Energy Assessment  
PA2503835

# Gelliondale Wind Farm

Officer Assessment

Department  
of Transport  
and Planning

Figure 10: Noise receivers within 5 km of the wind farm. Source: ENA.

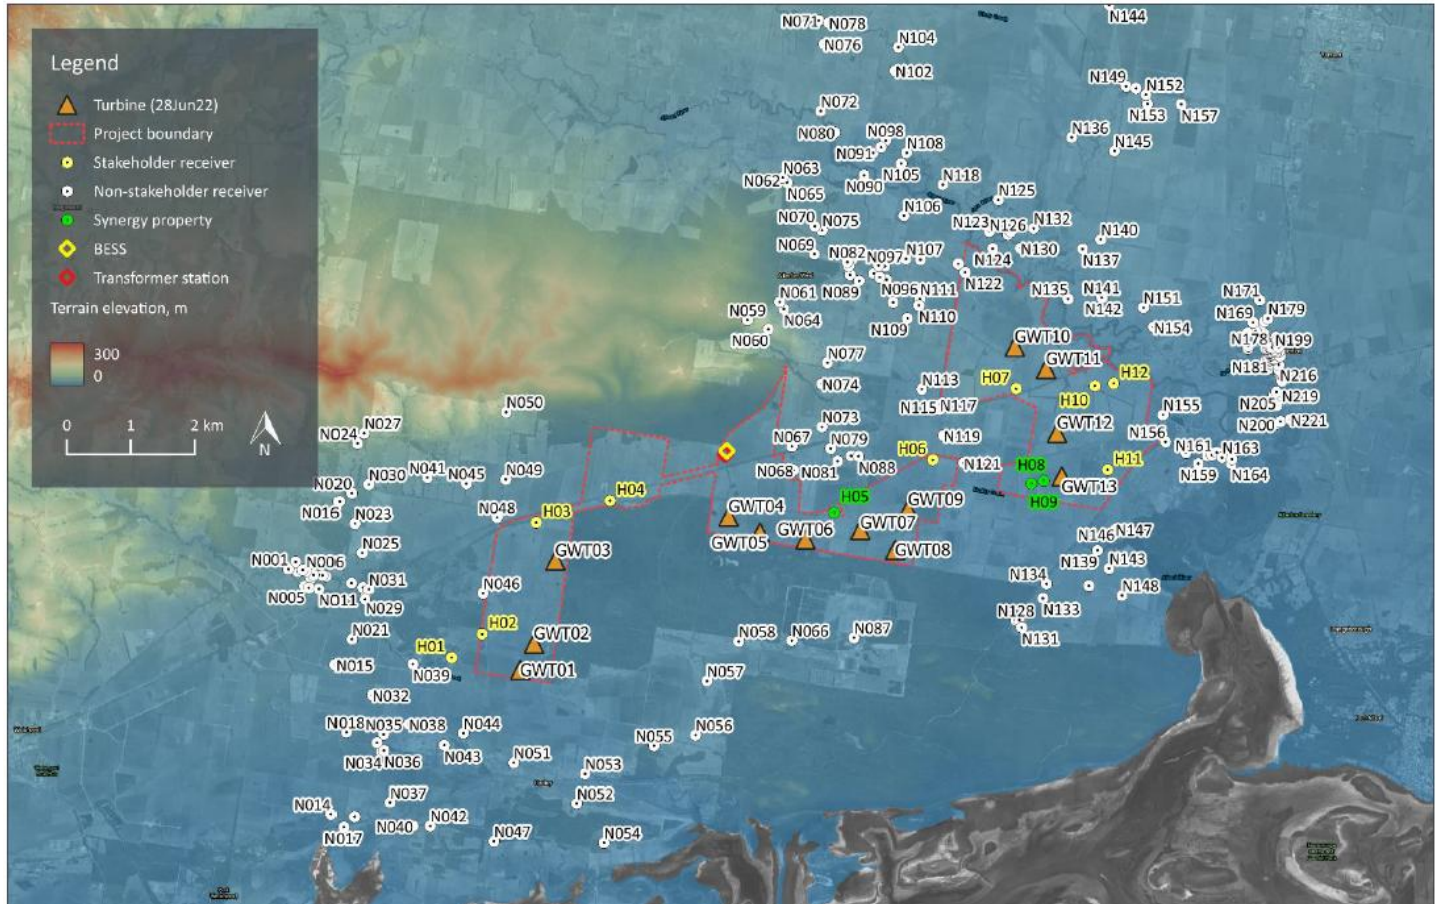
101. The acoustic assessment identified 230 receivers located within 5 km of the proposed turbines as shown below in Figure 10. This includes 11 stakeholder receivers located within the project boundary (H02-H12), and one stakeholder receiver (H01) outside of the project boundary:

102. Noise agreements are in place or proposed between the proponent and the landowners of receivers H01, H02, H03, H04, H06, H07, H10, H11 and H12. Additionally, receivers H05, H08 and H09 are owned by the proponent and are not intended to be used as dwellings when the wind farm is operational.
103. The ENA has identified the noise limits applicable to stakeholder and non-stakeholder receivers as shown below:

Figure 11: Excerpt of the ENA showing the noise contours. Source: ENA.

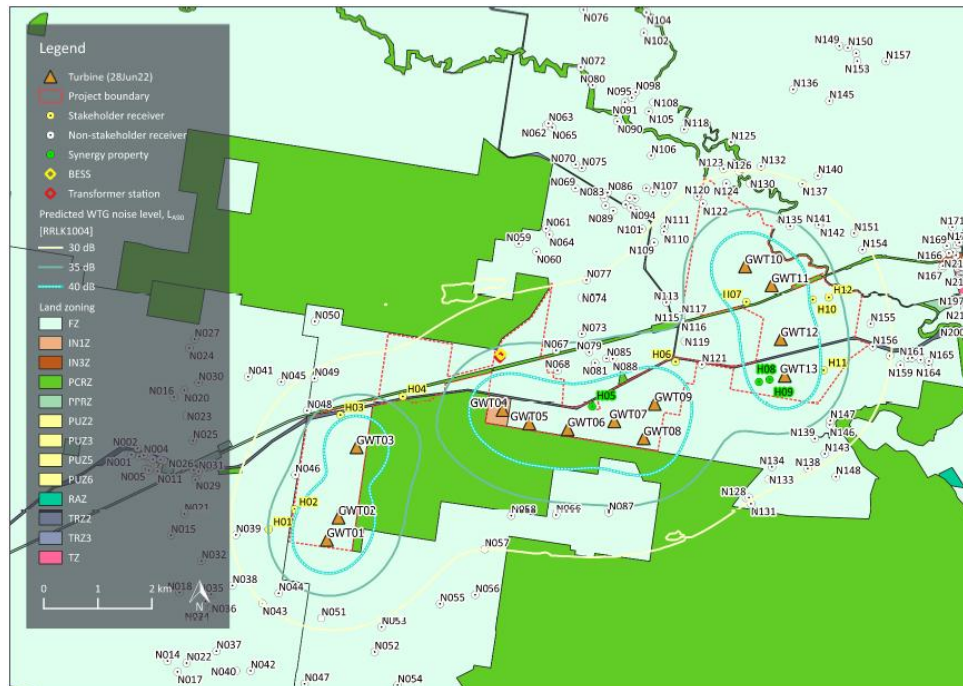
106. Dwellings H05 and H08 are also owned by the proponent and are predicted to comply with the relevant noise limit. The proponent has also stated that these dwellings will be decommissioned prior to operation.
107. Since the ENA was written, dwelling H13 was constructed and is therefore not specifically assessed by the ENA. However, dwelling H13 is in the same ownership as dwelling H03, and the noise contours on page 55 of the ENA demonstrate that H13 is predicted to experience similar turbine noise to H03 at approximately 38dB, which would comply with the applicable noise limit. Conditions of the permit will require the proponent to prepare an updated pre-construction predictive noise assessment prior to the commencement of construction which will include an assessment of dwelling H13 to confirm compliance.

108. The ENA did not assess cumulative wind farm noise levels, as the closest approved/operating wind farm is the Toora Wind Farm located over 15 km to the west.
